Date 2/11/2018
To Steve Ryan (Tactical Group)
From Westley Owers (Arcadis)/ Richard Johnson (Aspect)
Copy to Nathan Cairney (Tactical Group)
Subject MPW Stage 2 – DP&E assessment matrix – SIMTA summary response

Table 1 provides a summary of the comments raised by DP&E on 25 October 2018 in the MPW Stage 2 “Assessment Matrix”. The following classification (based on DP&E’s response) has been given to comments raised by DP&E:

Table 1 Summary of DP&E comments

Figure 7-1 Noise Wall and Buildings included in Noise Model

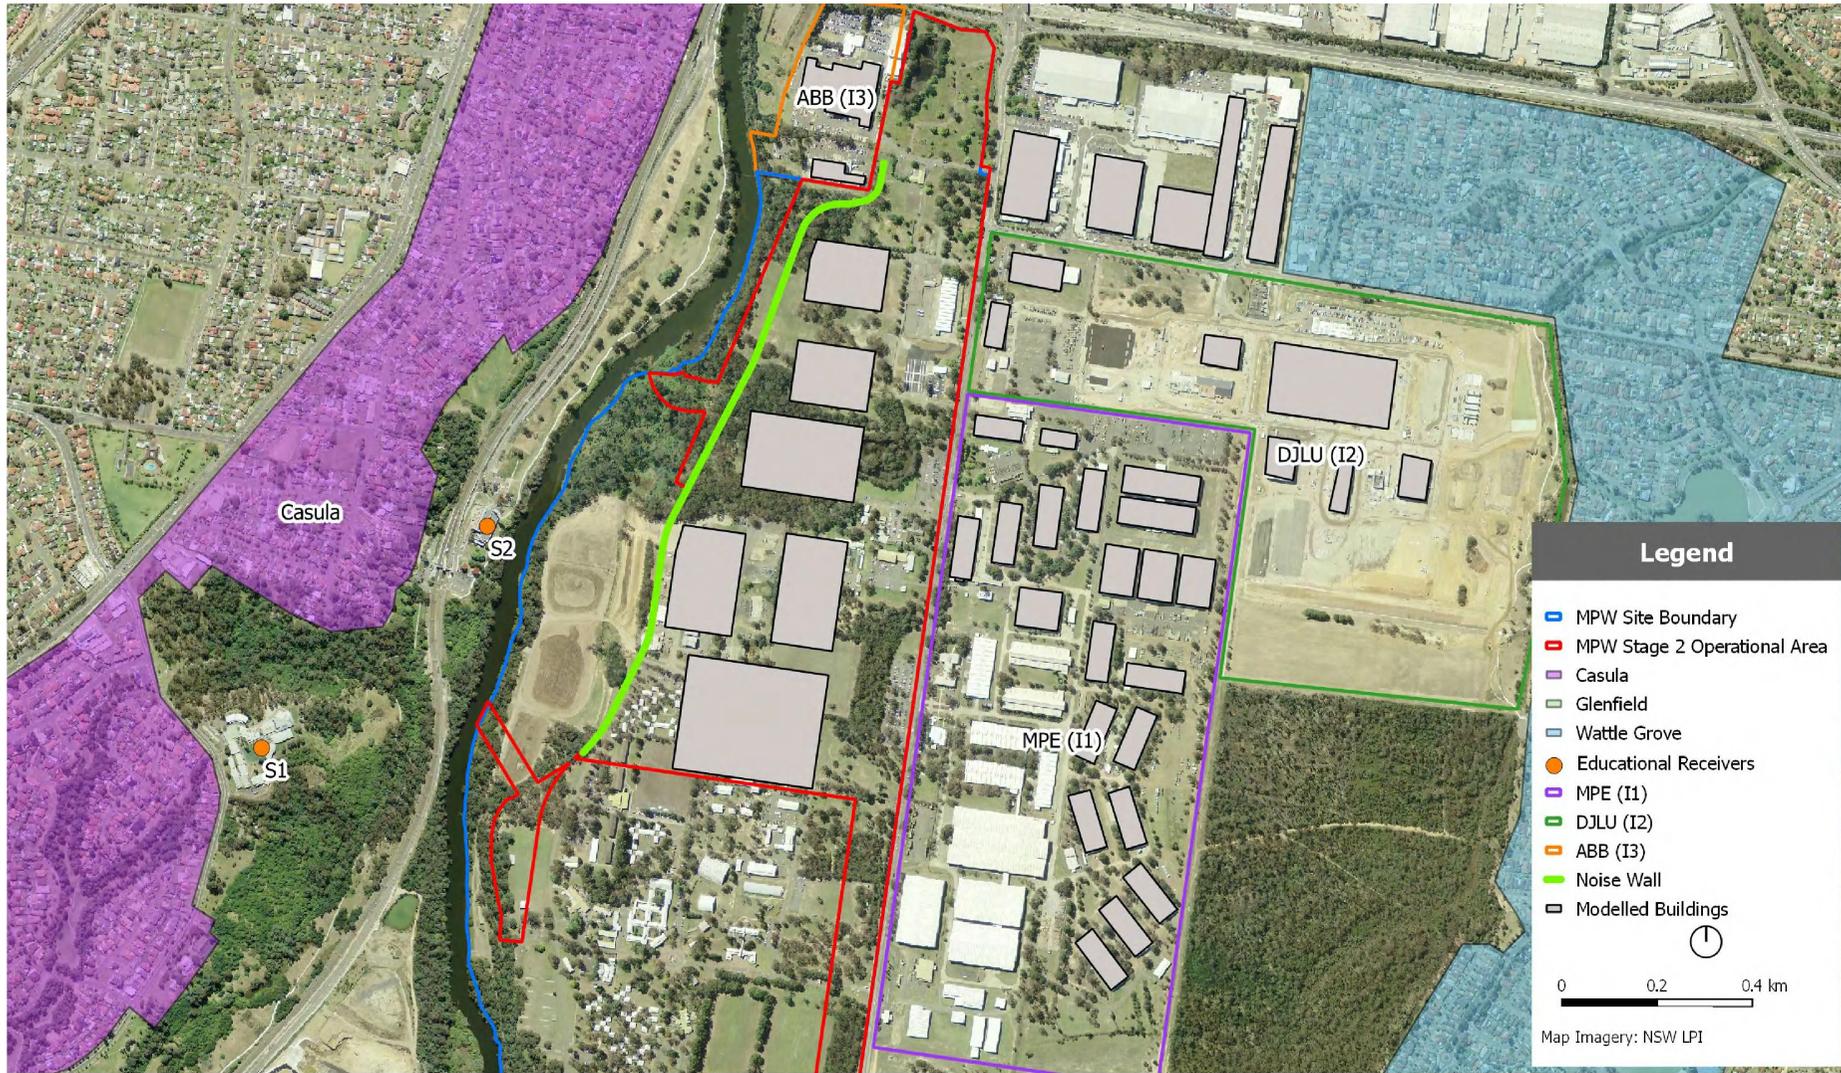
Issues for Assessment – Assessment Report unable to be Finalised	DP&E previous Classification	Initial response	Discussion notes
Key issues			
1. unable to assess operational noise impacts	Item not considered adequate	<ul style="list-style-type: none"> A review of noise assessment and mitigation measures for the noise wall consideration has been prepared and provided within Appendix A. 	Considered addressed.

*“As outlined in Section 7.1.3, a large noise wall would be established along a portion of the western boundary of the Proposal site. **The need for this noise wall was identified in the MPW Concept Plan EIS, and subsequent modelling in this assessment has confirmed the need for such a barrier.** The indicative height and extent of the noise wall was presented in Section 7.1.3. **The actual height and extent of the noise wall, and any other required noise walls, would be confirmed during detailed design. It should be noted that the height and/or extent of the noise wall could differ from that presented in this assessment.**”*

Project	
MOOREBANK PRECINCT WEST - STAGE 2	
Title	
GENERAL ARRANGEMENT PLAN

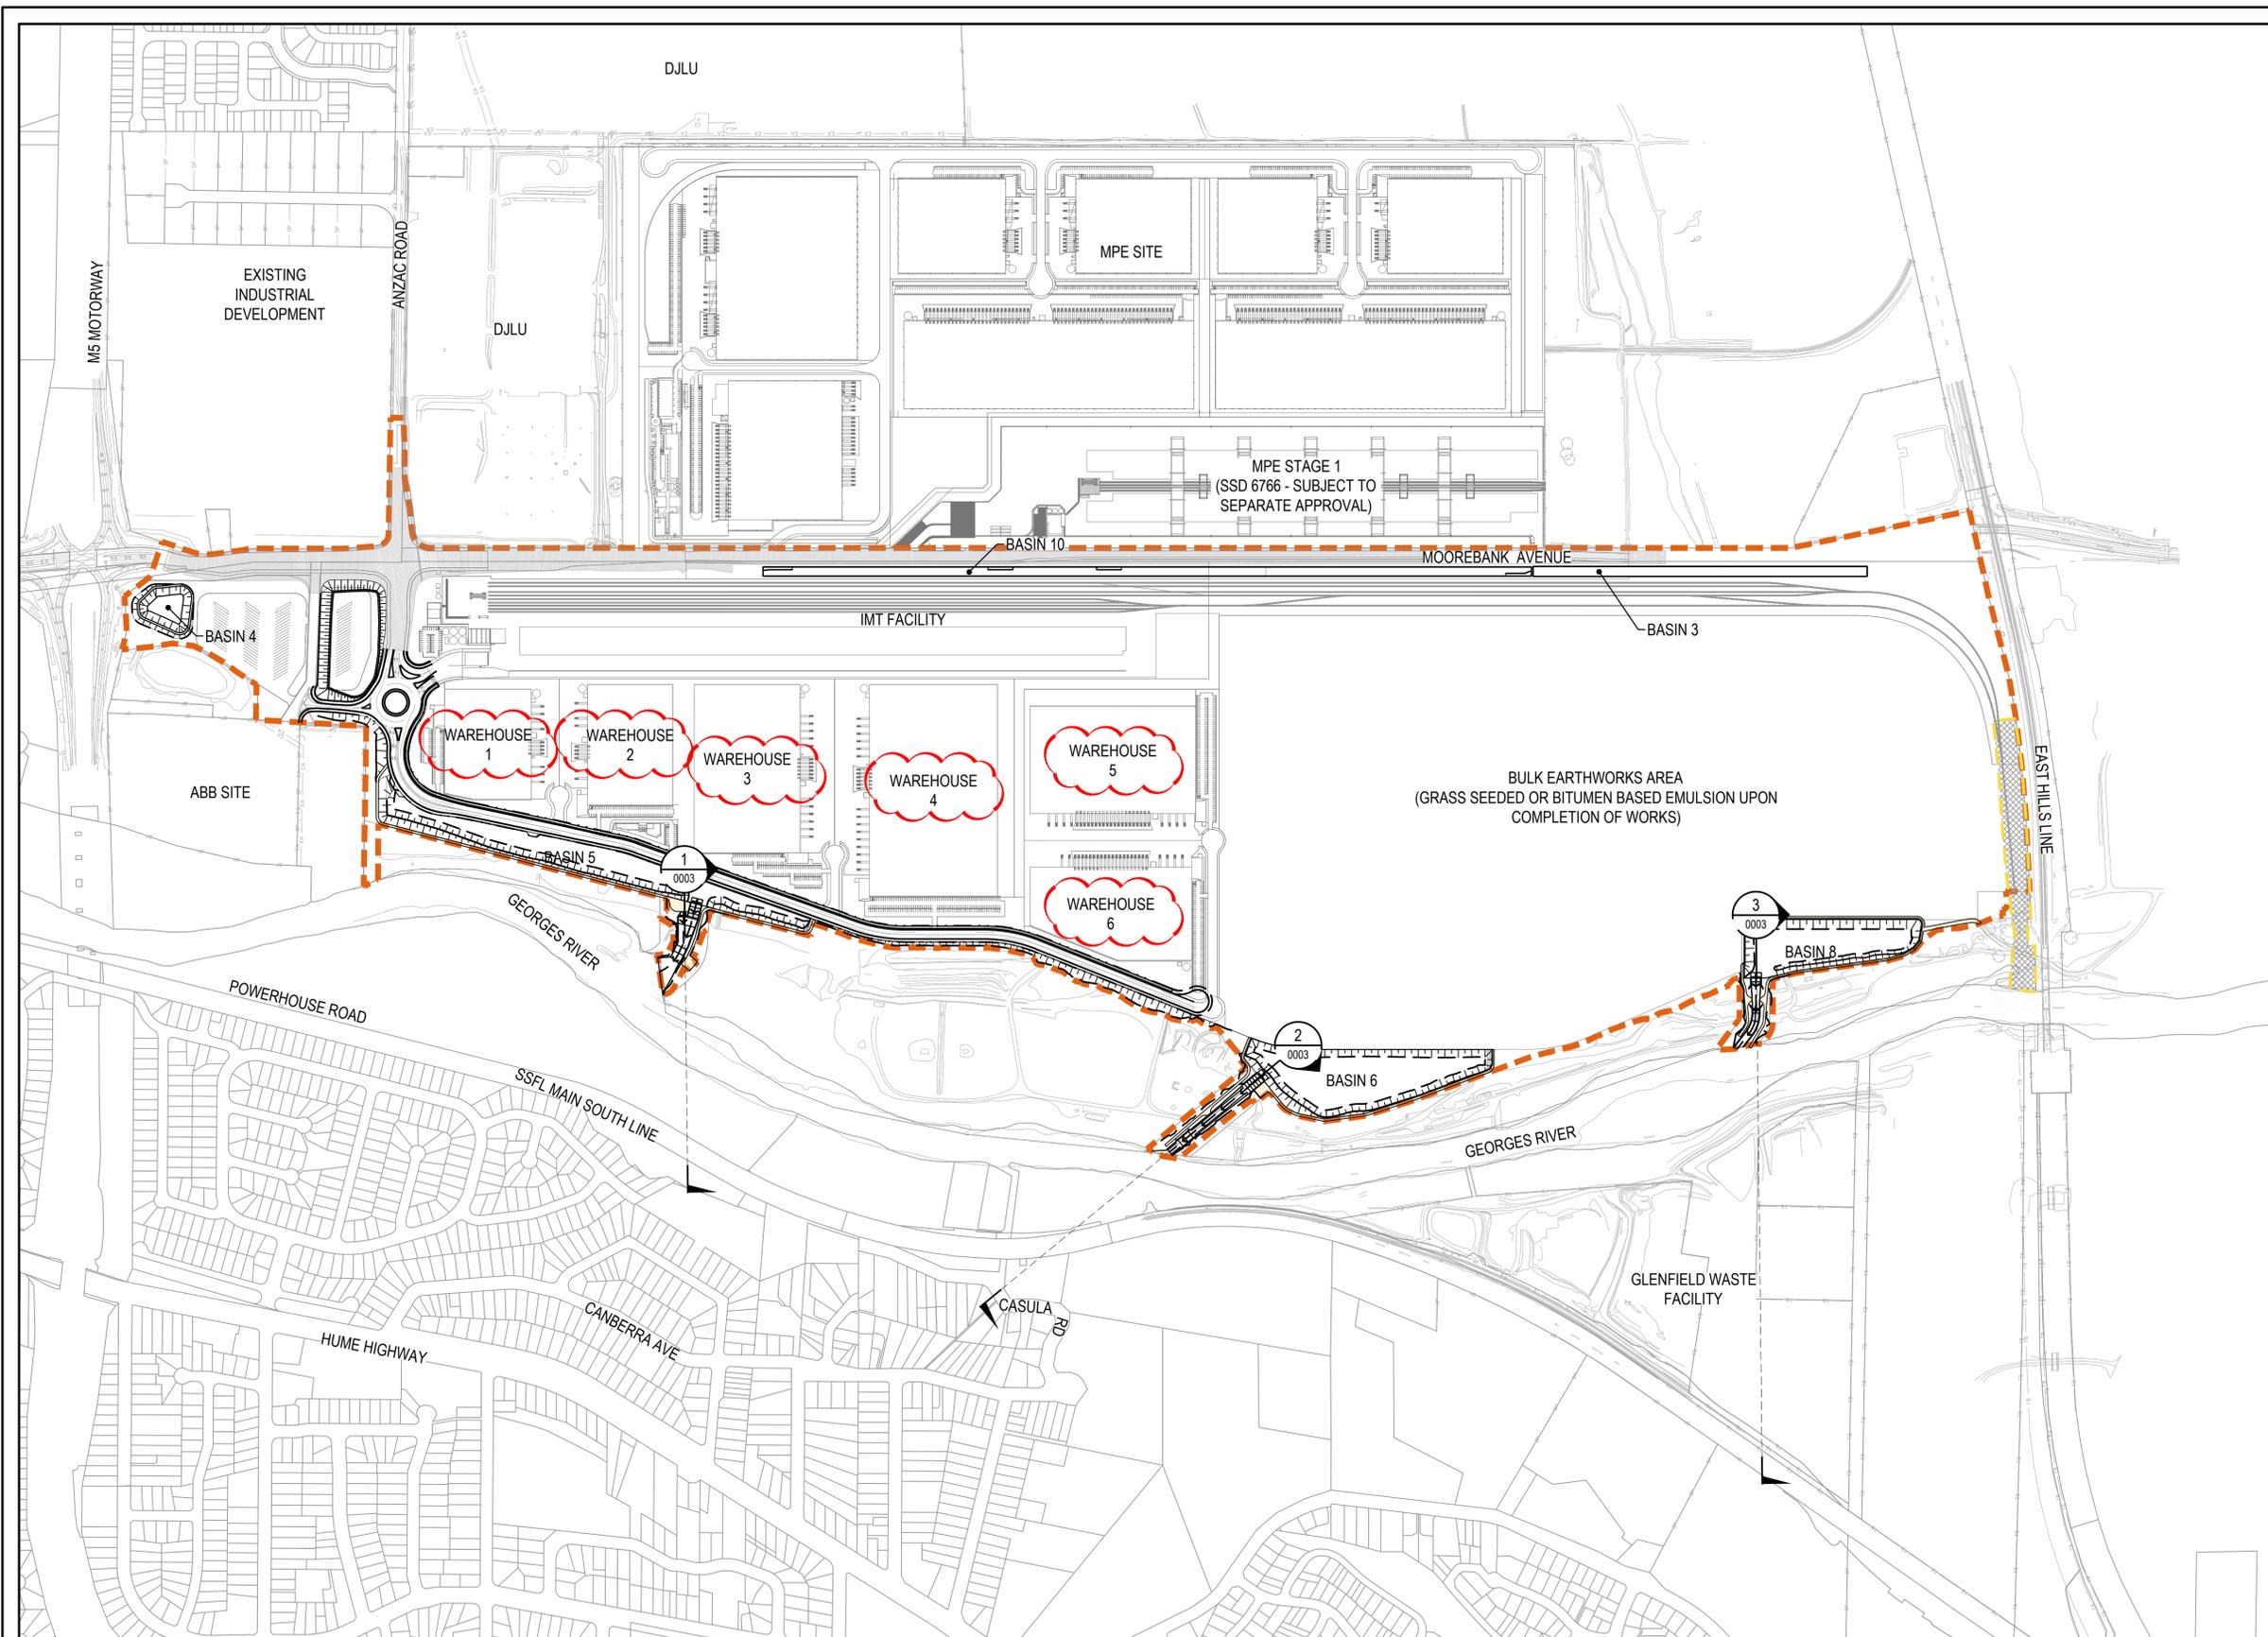
2.14(iii) fill batters removed from plan, no information provided	Item not considered adequate	<ul style="list-style-type: none"> Fill batters have been provided on plans, as identified in the Civil Design Drawings (MPW2-ARC-CV-DWG- 0002) – Refer to Appendix B. 	For discussion with DP&E.

Project	MOOREBANK PRECINCT WEST - STAGE 2
Title	BULK EARTHWORKS SECTIONS SHEET 1

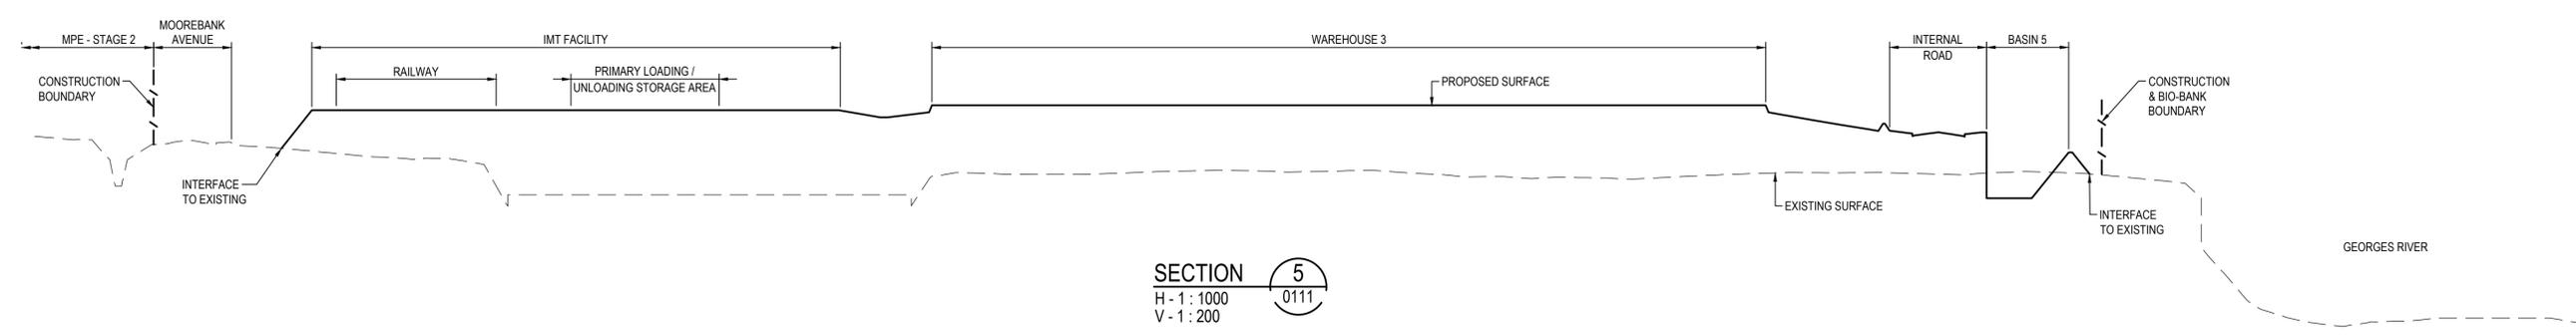
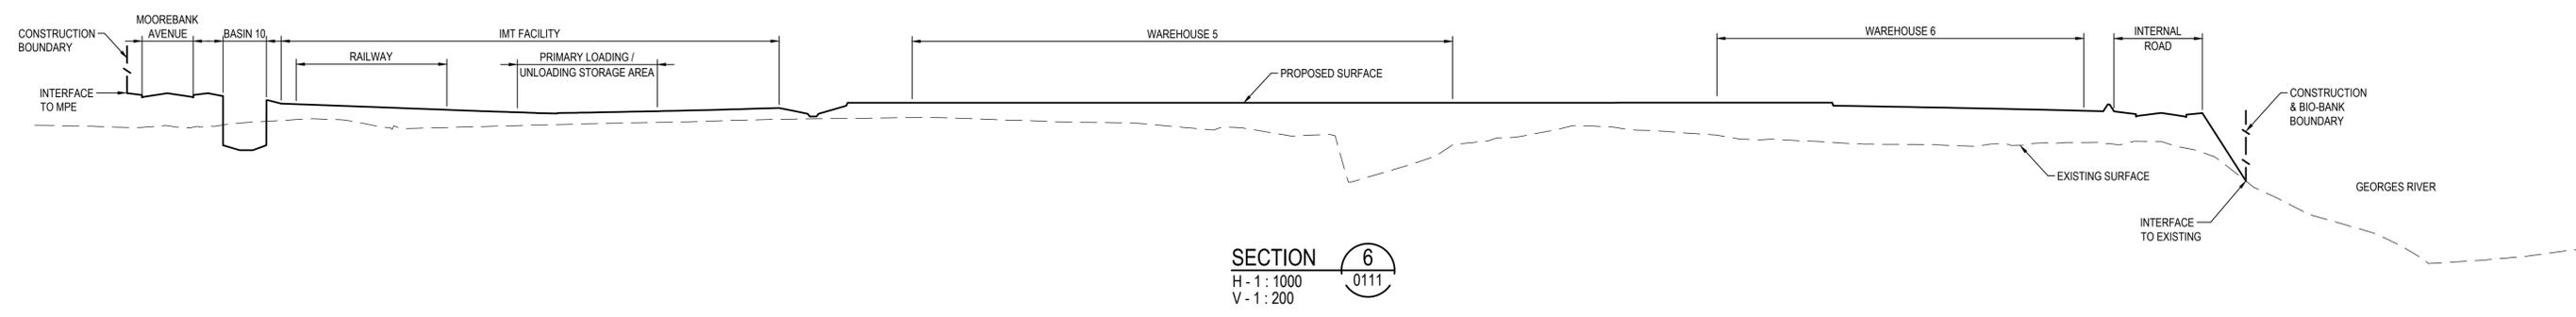
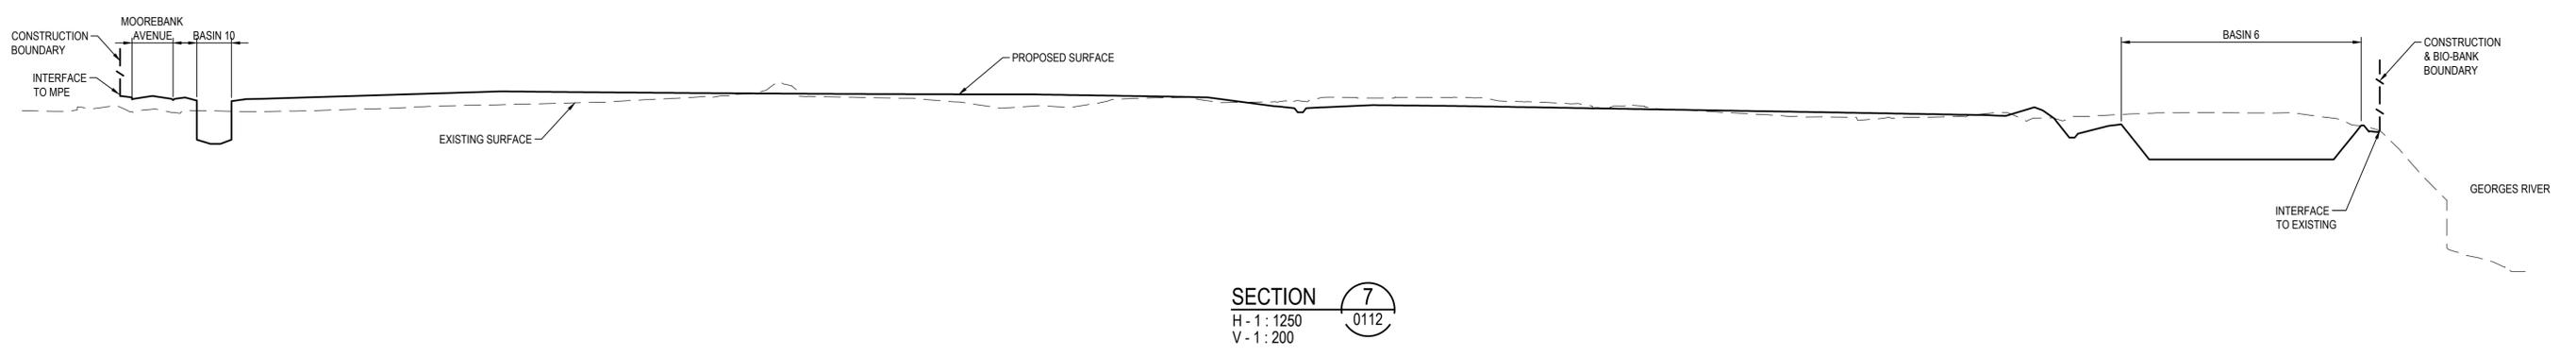
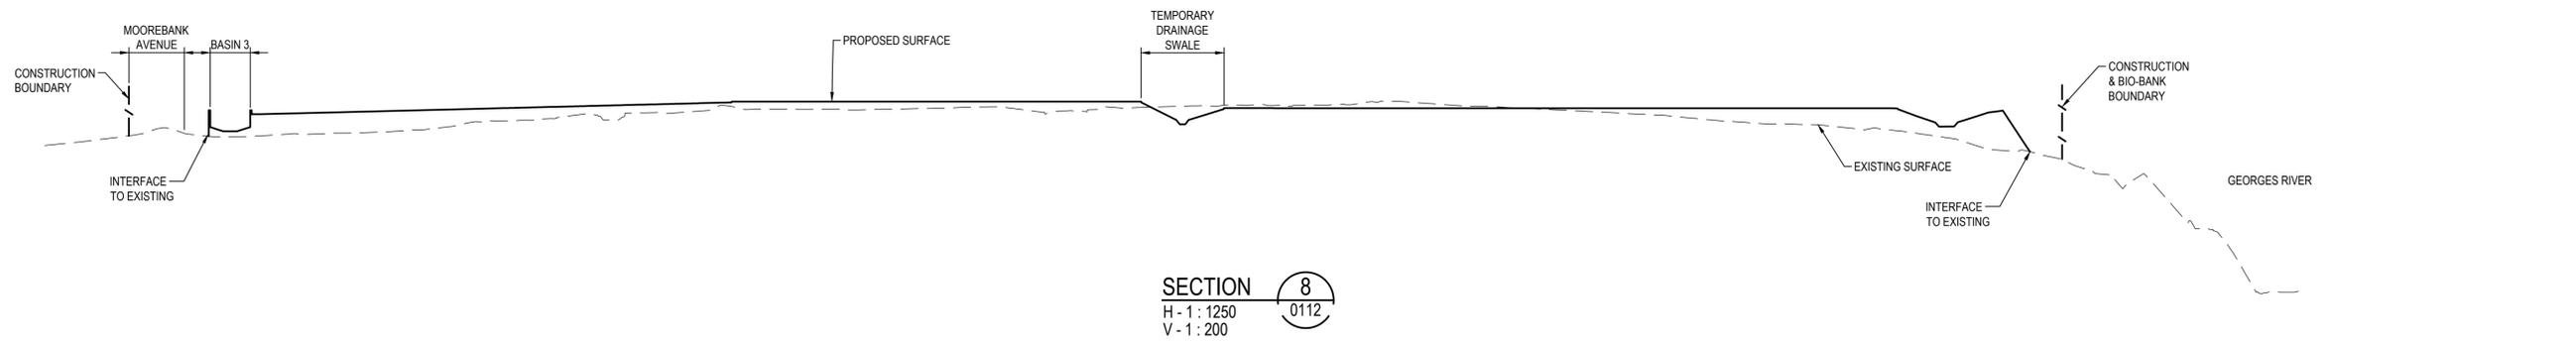
Issues for Assessment – Assessment Report unable to be Finalised	DP&E previous Classification	Initial response	Discussion notes
3. Revised C-MIC2-SSD-116/117 (Earthworks Sections Sheet 1 and 2) Cross-Sections including noise wall showing tie in to existing adjacent surface levels, location of top of bank to the Georges River and extension of cross-sections/ additional cross-section as follows:

3.1 extension of Section 2 to the north to show tie in with existing levels (also to show location of boundary between Lot 1 DP 1197707 and Lot 3 DP 32998 (ABB site))	Outstanding item	<ul style="list-style-type: none"> Civil Design Drawings (MPW2-ARC-CV-DWG- 0121) – Refer to Appendix B. 	Considered addressed.

3.3 extension of Section 3 to the south to show tie in with the railway embankment	Outstanding item	<ul style="list-style-type: none"> Civil Design Drawings (MPW2-ARC-CV-DWG- 0121) – Refer to Appendix B. 	Considered addressed.

Title
BULK EARTHWORKS SECTIONS SHEET 2

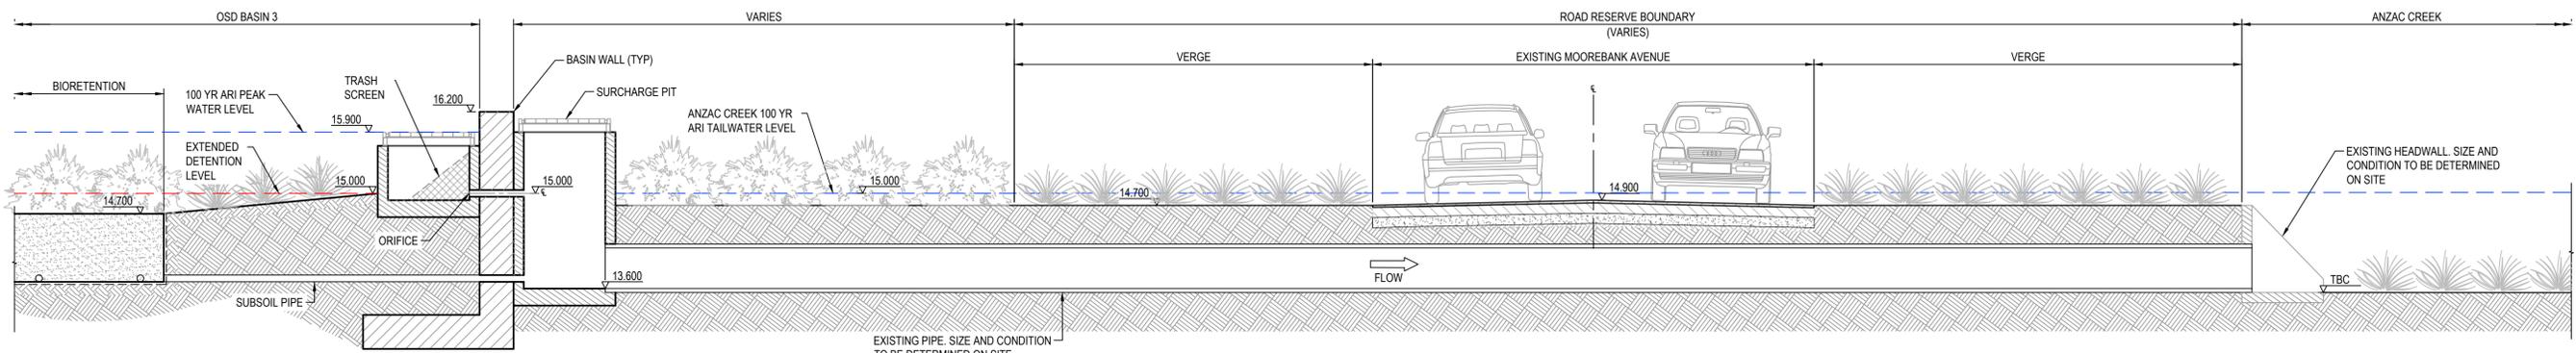
2. Revised Stormwater Design Plans at 1:1000 @ A1 (similar to SKC-MIC2-035 to 043 Detailed Proposed Catchment Plans) showing			
2.2 site boundary- previously shown, now removed	Item not considered adequate	<ul style="list-style-type: none"> This information has now been provided within the Civil Design Drawings (MPW2-ARC-CV-DWG-0121-0122) – Refer to Appendix B. 	Considered addressed.
